## Design Changes Matrix

This is the Ground Floor presented to Councillor on 25th Feb 2021

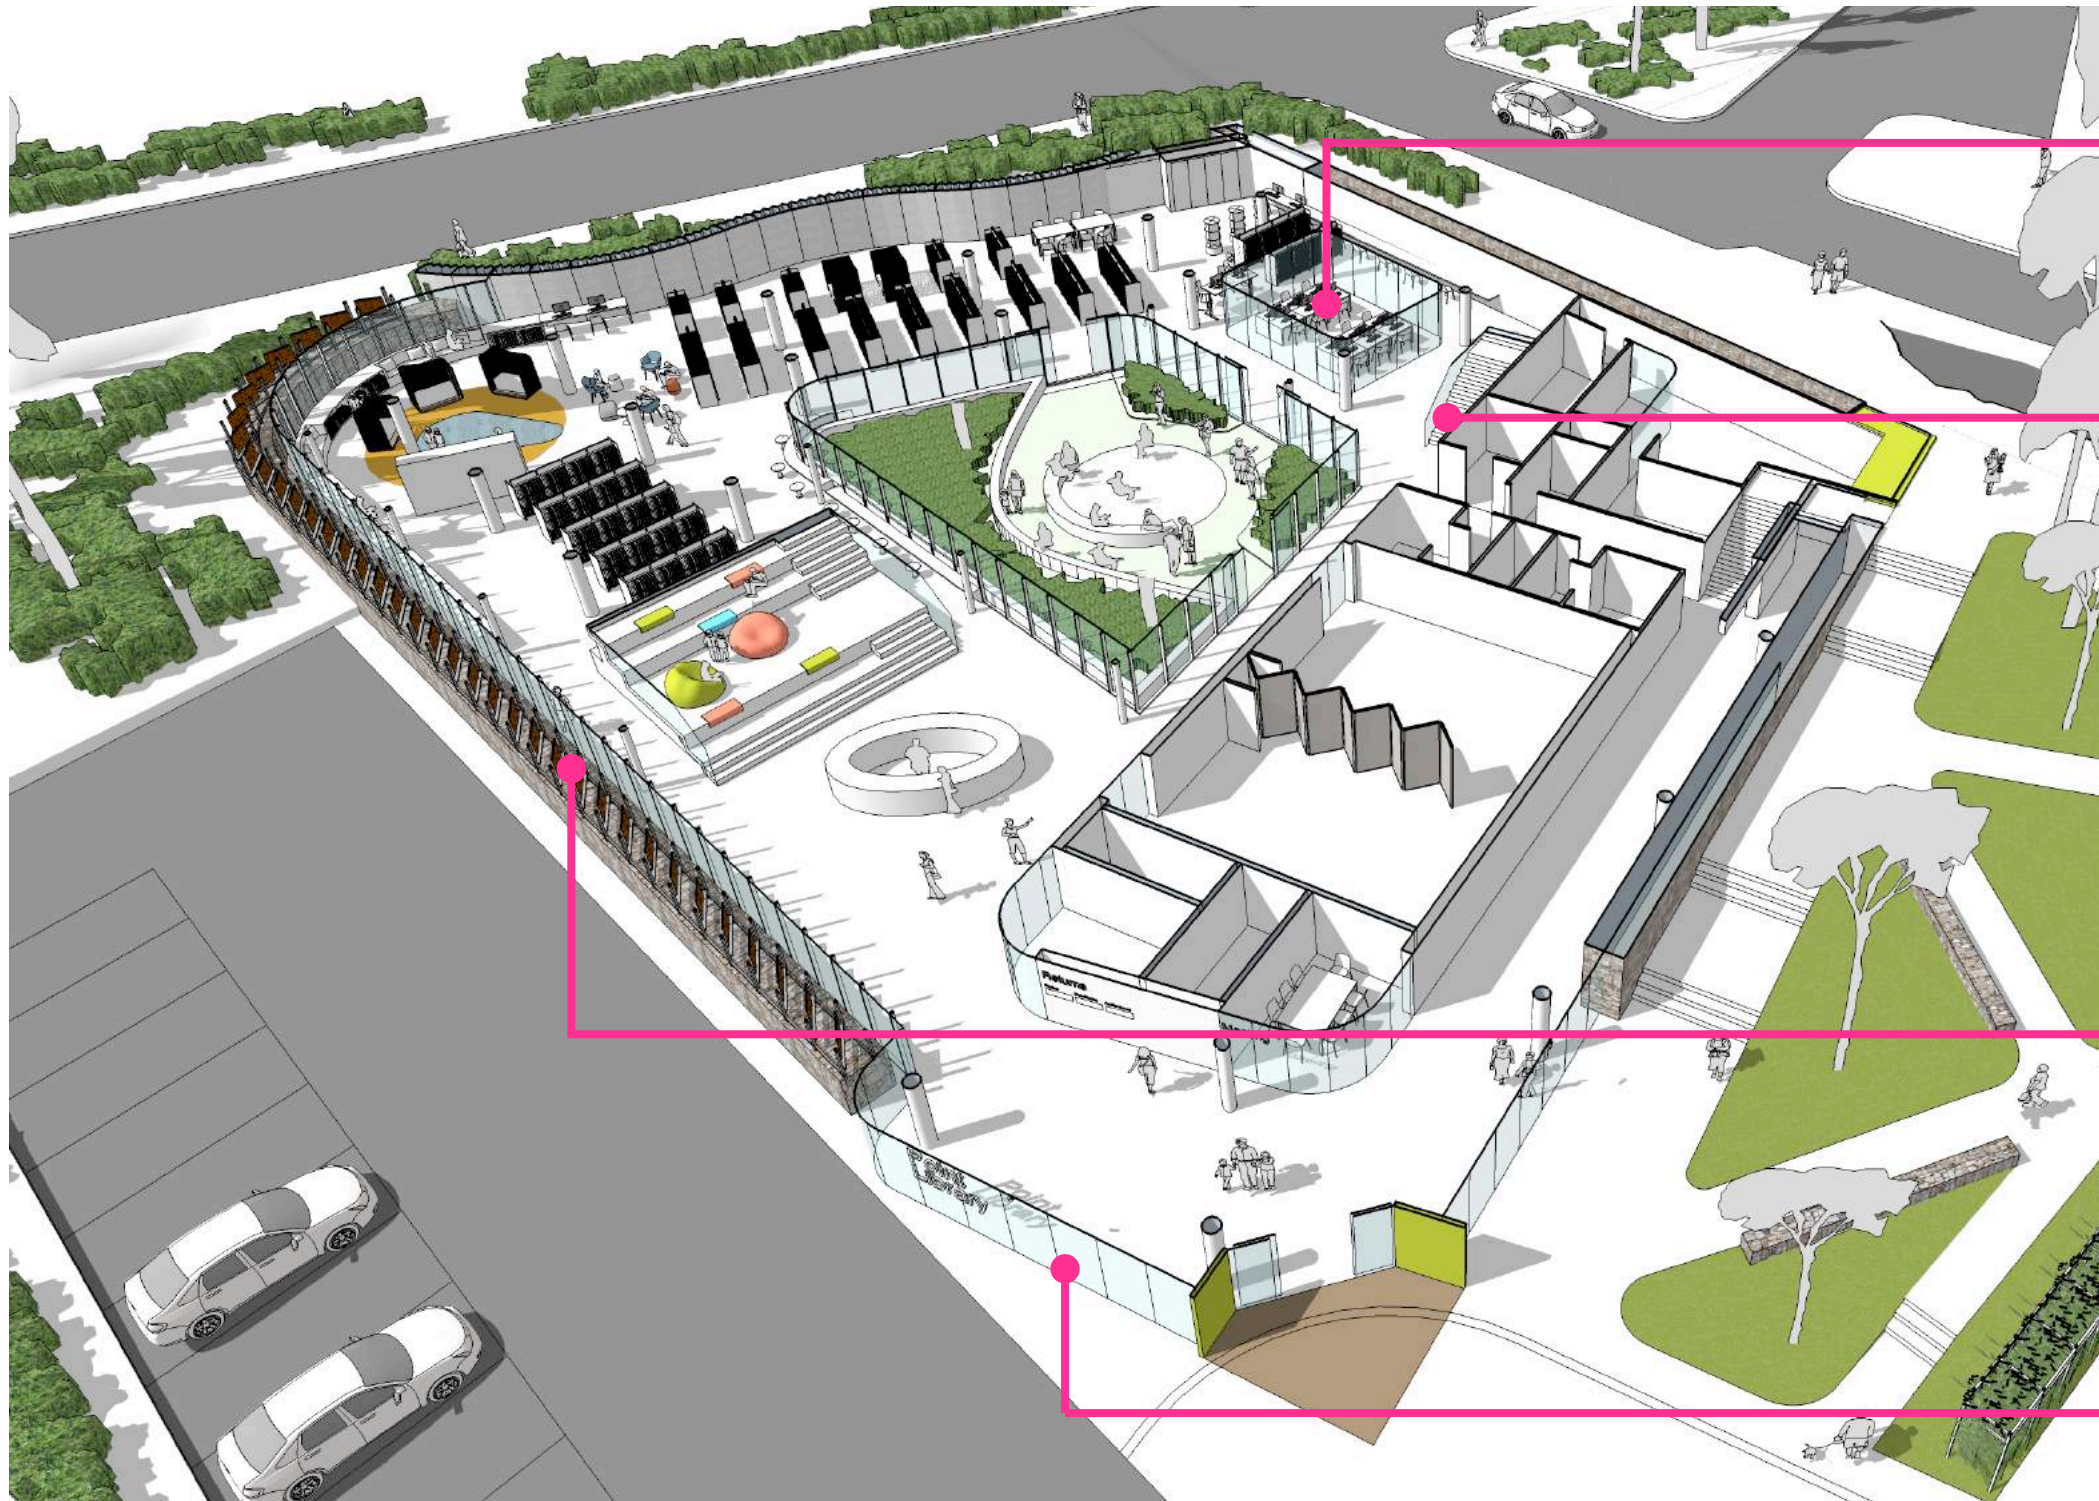
Research Room relocated to make way for new location of Stairwell in the Community Presentation Documents & PreDA Documents

Stairwell relocated to assist with mechanical reticulation in the Community Presentation Documents & PreDA Documents.

A solid precast wall incorporated to reduce heat gain in the Community Presentation Documents & PreDA Documents.

This is the Upper Floor presented to Councillor on 25th Feb 2021

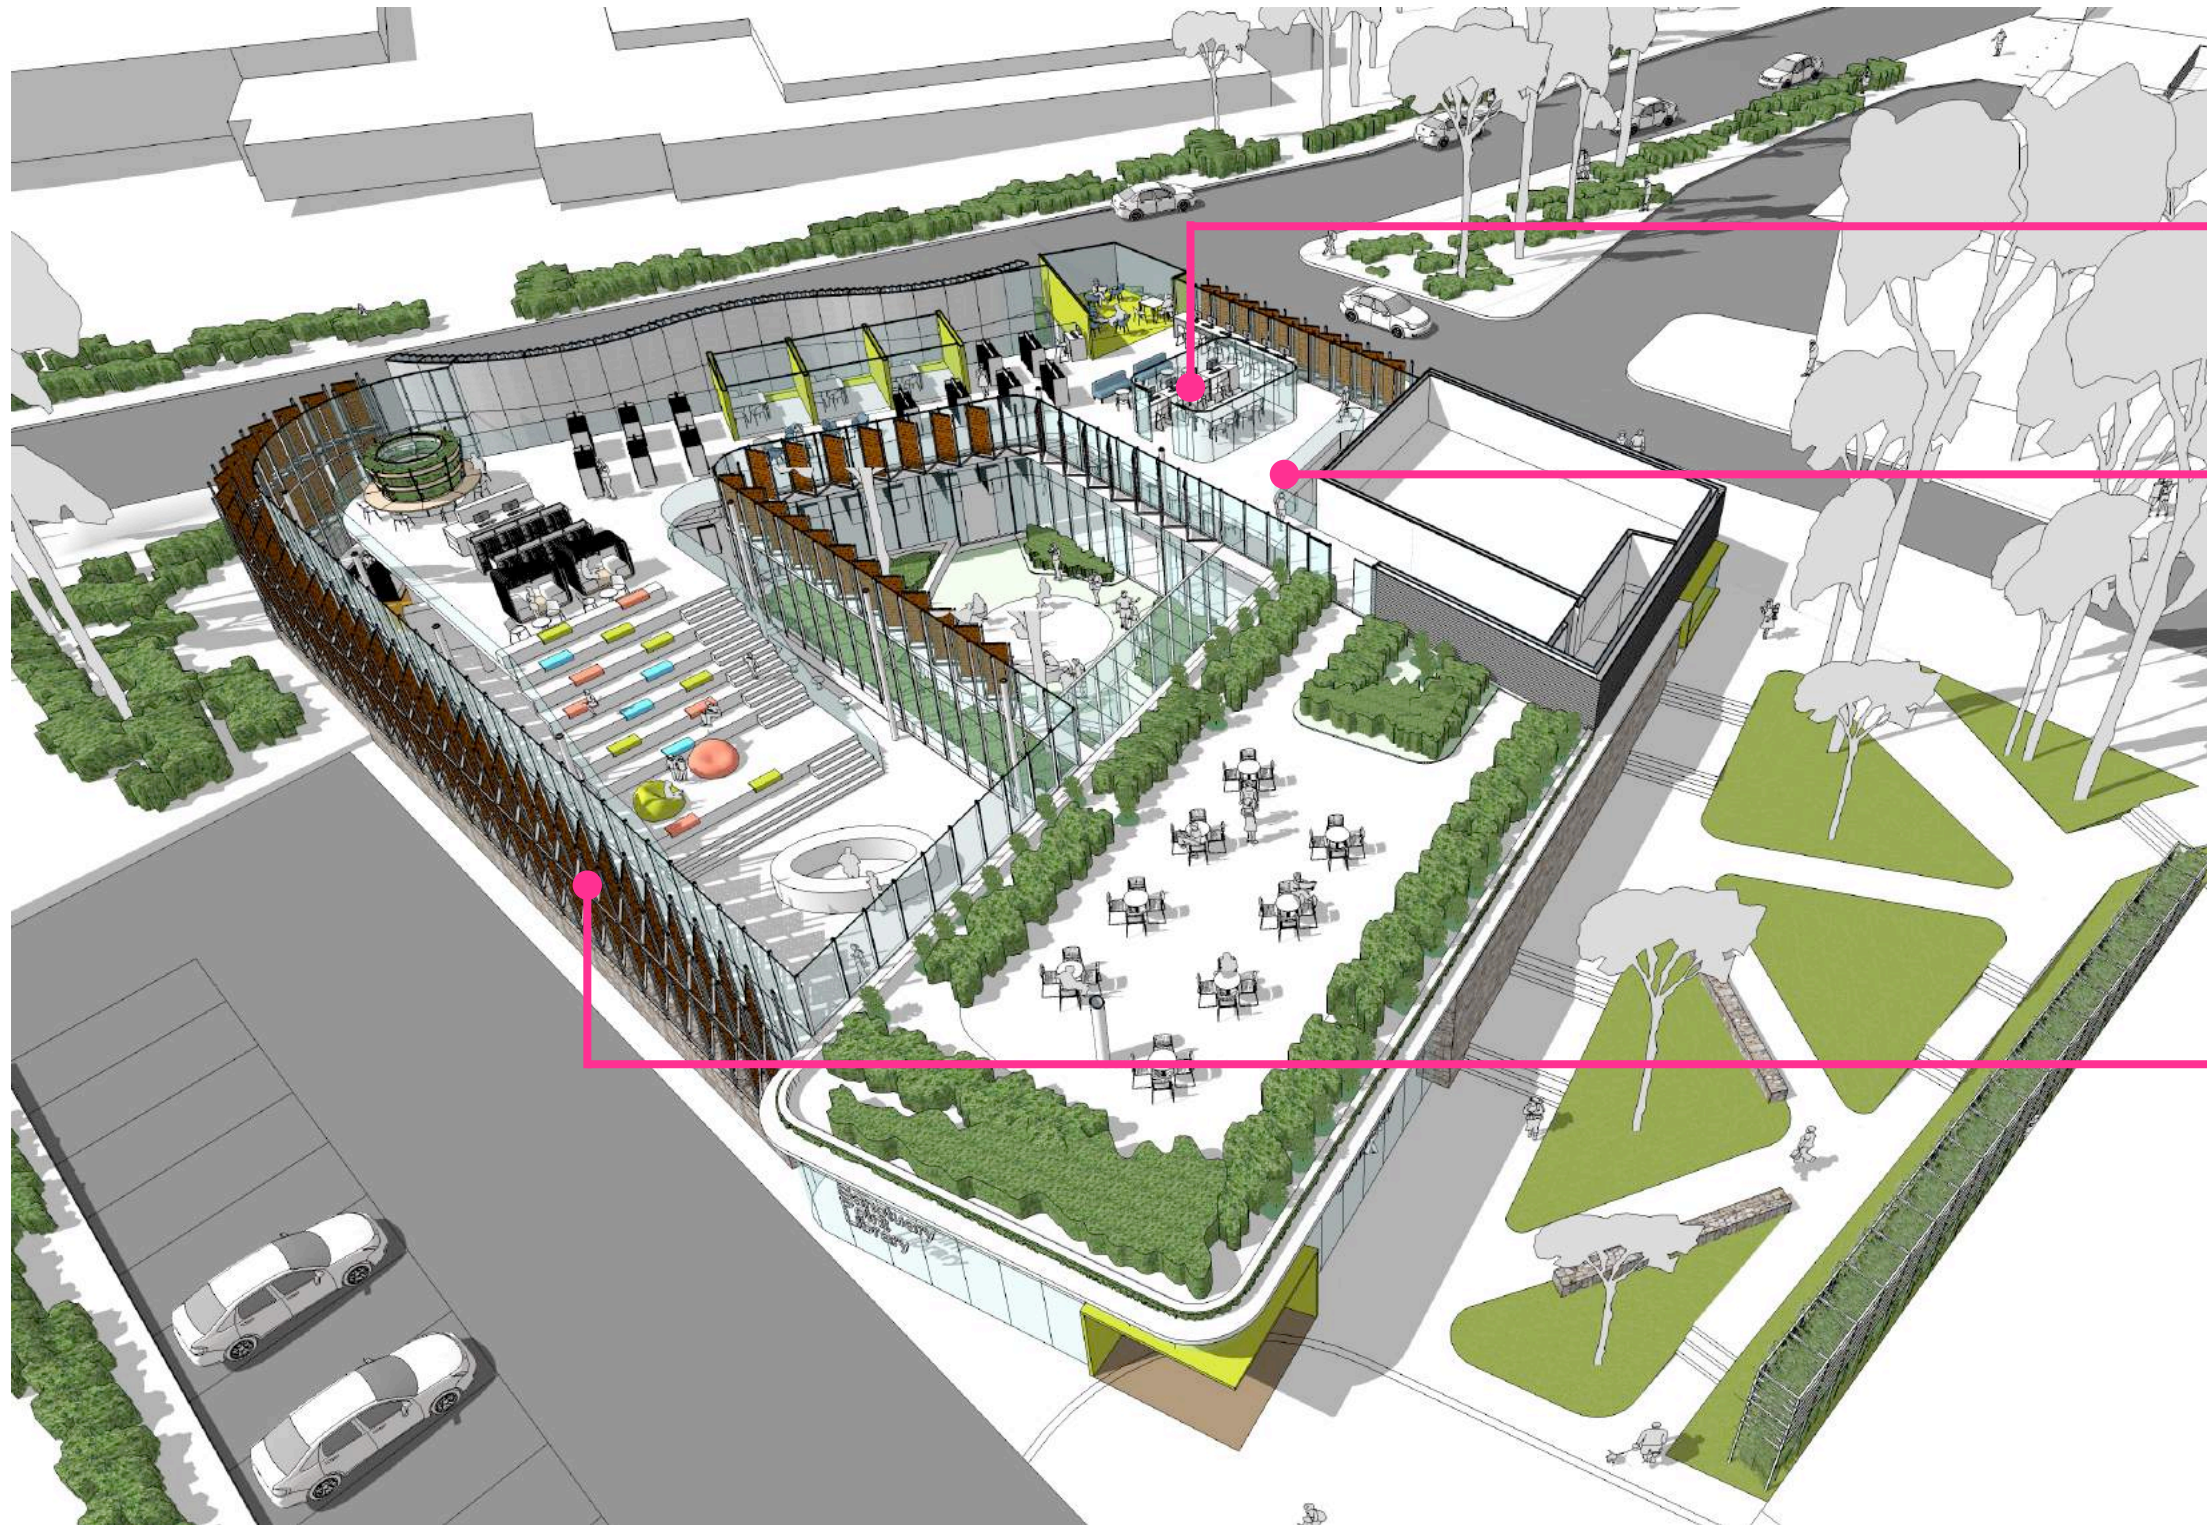
Research Room relocated to make way for new location of Stairwell in the Community Presentation Documents & PreDA Documents

Stairwell relocated to assist with mechanical reticulation in the Community Presentation Documents & PreDA Documents.

Breakup of the sunshade modified in coordination with graphics strategy for artwork in the Community Presentation Documents & PreDA Documents

This is the Ground Floor presented to Community Presentation Day on 13 & 20 April 2021 and Pre DA

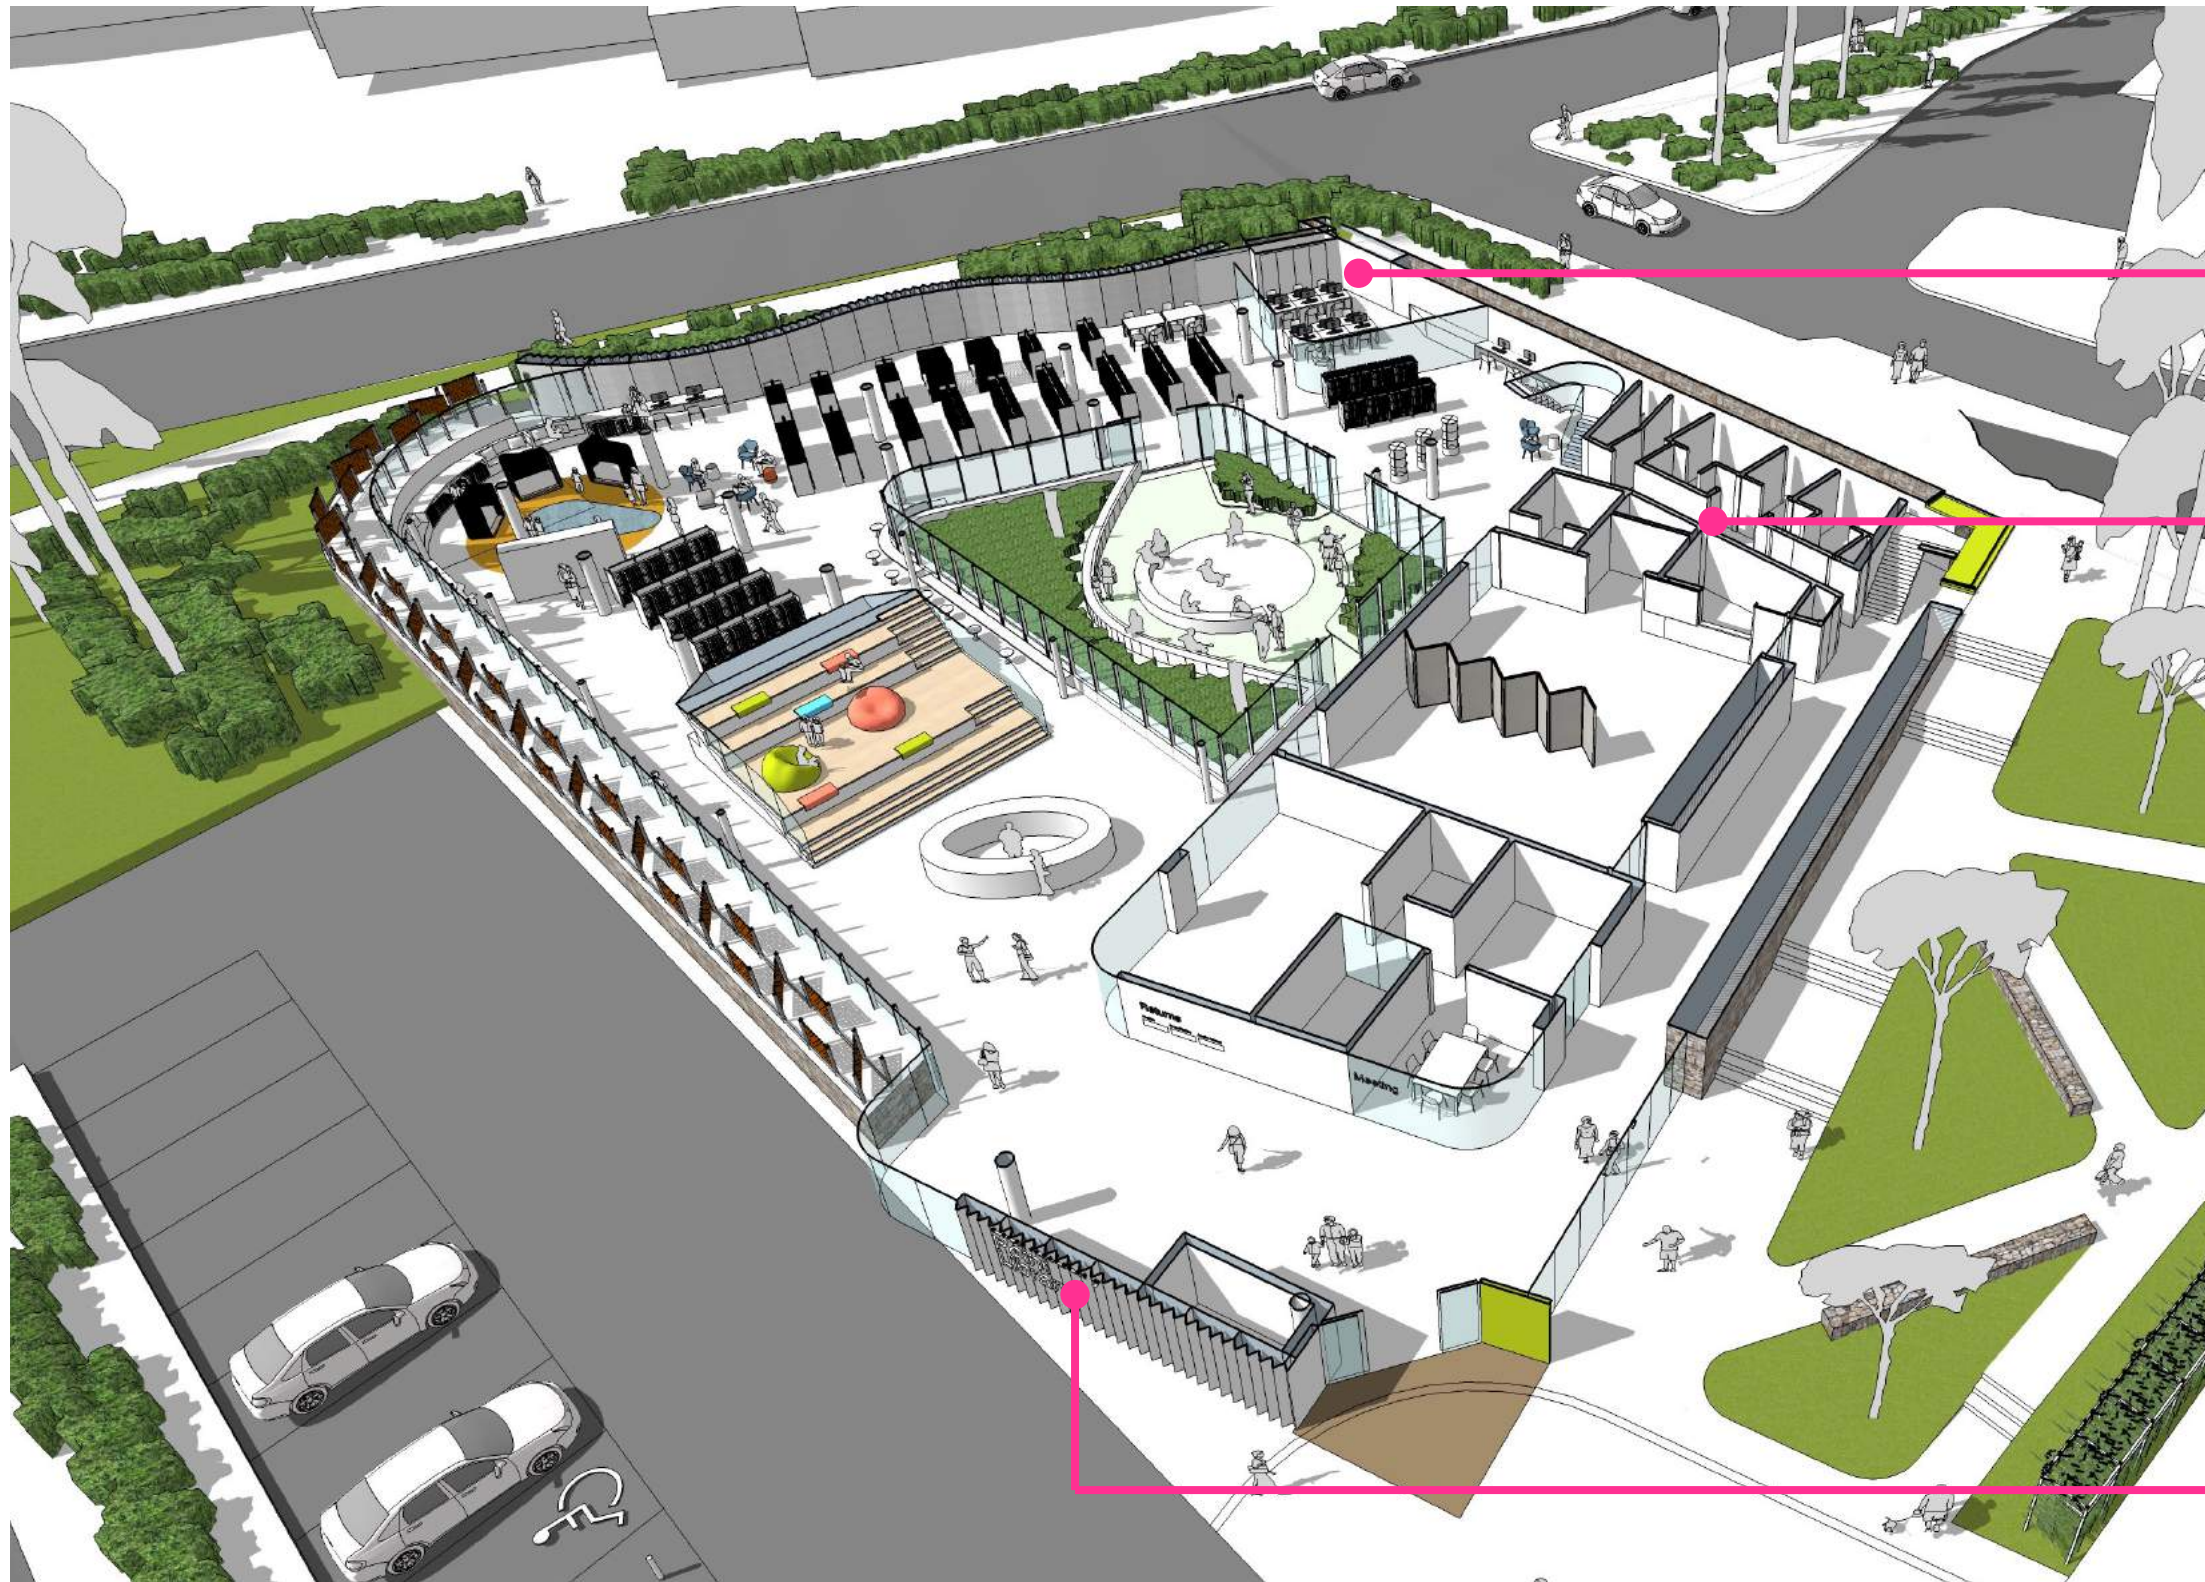
Changes:  
Technology Room relocated to north east corner

Changes:  
Corridor & lift relocated

Changes:  
A solid precast wall incorporated
